ED-HMI3120-133C

PCN

by EDA Technology Co., Ltd

Product Change Notice 1

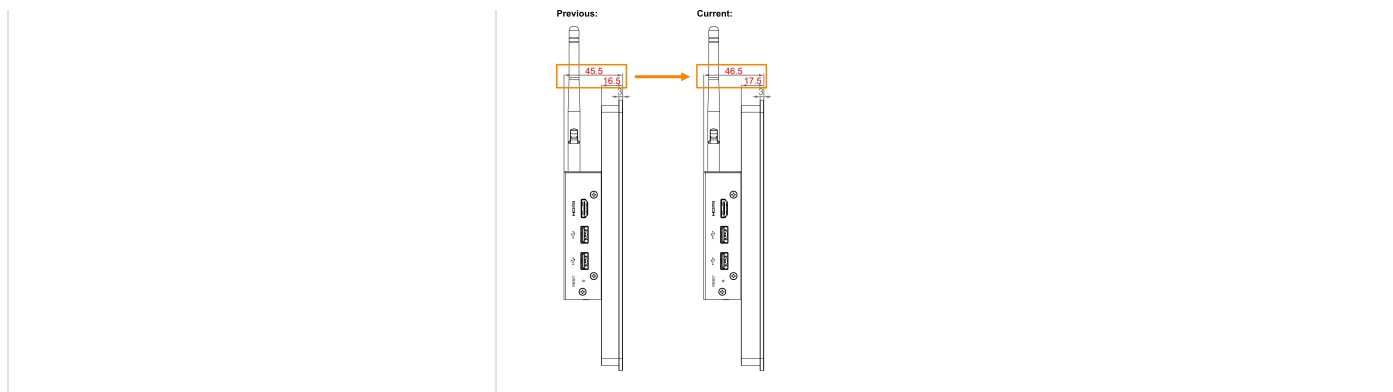
Changes	Results
LCD bezel thickness increased by 1mm	We have optimized the LCD bezel structure to provide additional clearance for internal cable routing. - LCD bezel thickness: adjusted from 16.5mm to 17.5mm. - Total product thickness: correspondingly adjusted from 45.5mm to 46.5mm.
